Certificate of Appropriateness

2549 N. Terrace Ave., North Point North Historic District

Replace the two front porch columns with round circular cedar columns on a square white base. Replace two lonic capitals with cedar Greek Ionic capitals to match existing in proportion and size.

Existing porch columns

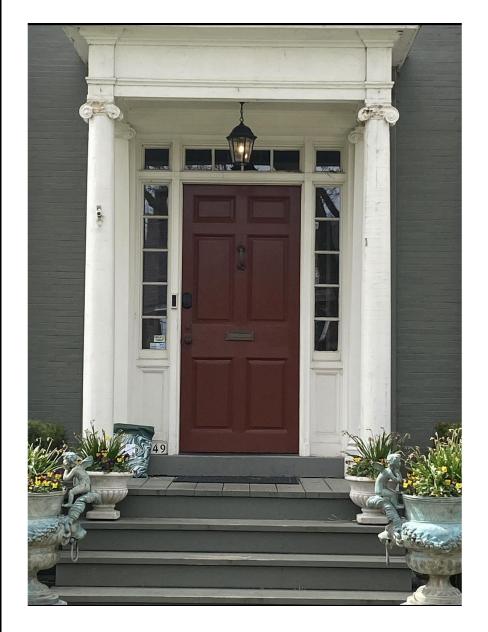
All finish wood must be smooth and free of knots and must be painted or treated with an opaque stain upon completion. Note: when new, bare wood is left exposed to the exterior elements for a period of only a week or two, the life the of the paint job subsequently applied to it will be decreased. The use of a decay-resistant wood for is required for porch areas. Using western white pine or Ponderosa pine is "at your own risk" because this wood has no natural decay resistance and can deteriorate in some exterior settings in just a few years.
